SUBJECT: NORTH ANNA POWER STATION, UNIT 2 - AMERICAN SOCIETY OF
MECHANICAL ENGINEERS BOILER AND PRESSURE VESSEL CODE,
SECTION XI RELIEF REQUEST CMP-020 (TAC NO. MB7515)

SAFETY EVALUATION BY THE OFFICE OF NUCLEAR REACTOR REGULATION

RELIEF REQUEST CMP-020

NORTH ANNA POWER STATION, UNIT 2

Cross-sectional view of head-to-flange Weld 1 showing the required inspection volume (within dashed lines), weld and UT beam. The figure illustrates that inspection from the flange side is severely limited due to transition angle and location of weld.

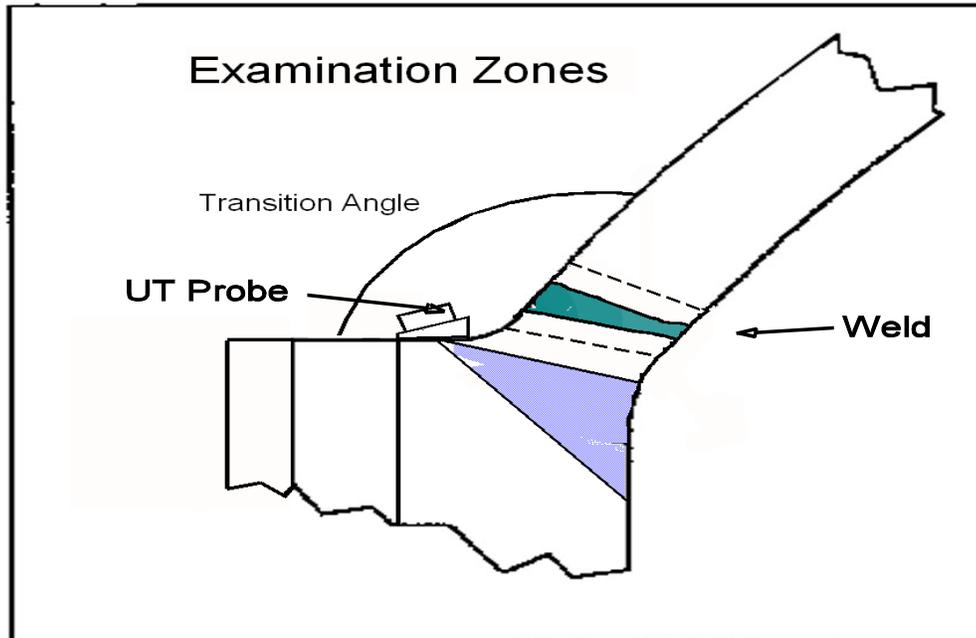
The examination volume for the Reactor Head-to-Flange Weld is defined in Figure IWB-2500-5. The examination volume can be scanned along the weld axis from two directions. However, due to the extreme angle of the transition from the curvature of the

head base material to the flange (See figure 1 below)¹, access for scanning perpendicular to the weld axis is restricted to only the head side of the weld.

Scanning from the flange side of the weld is limited to 0.5 inches from the weld toe due to the flange configuration.

In addition, three lifting lugs are located approximately 120° apart and each lug obstructs the volumetric scanning for approximately 4% of the weld length.

The cross-sectional geometry of the component at Weld 1 produces a high transition angle between the flange and the domed head. As illustrated in Figure 1, scanning from the flange side of the weld is severely limited due to location of the weld and the transition angle. In addition, the location of three closure head lifting lugs further restrict access for ultrasonic examination. For these reasons, the component configuration does not allow the licensee to obtain the full Code-required volumetric coverage from both sides of the weld. For the licensee to achieve 100% volumetric coverage, the RPV closure head would have to be redesigned and modified. This would place a significant burden on the licensee, thus the Code-required 100% volumetric examination is impractical for Weld 1.

As shown on the sketches and technical descriptions² provided by the licensee, a substantial amount (approximately 66%) of the Code-required examination volume can be obtained with the perpendicular, parallel and 0° ultrasonic scans performed from the head side of the weld. For both the 45° and 60° scans, the licensee was able to achieve the Code-required coverage from a single side. Apart from the Code volumetric examinations, the licensee also performs a separate 65° shear wave ultrasonic inspection from the head side of the weld to produce a sound field nearly perpendicular to the weld/base metal interface, as recommended by NRC Regulatory Guide 1.150, *Ultrasonic Testing of Reactor Vessel Welds During Preservice and Inservice Examinations*, Rev.1, February 1983. In addition to the volumetric examinations of this weld, the licensee was able to obtain essentially 100% of the Code-required surface examinations performed on the outside of the component. The examinations completed by the licensee establish a reasonable basis for comparison with future inservice examinations and should have detected any significant conditions that might challenge the structural integrity of the subject welds. Therefore, pursuant to 10 CFR 50.55a(g)(6)(i), it is recommended that relief be granted.
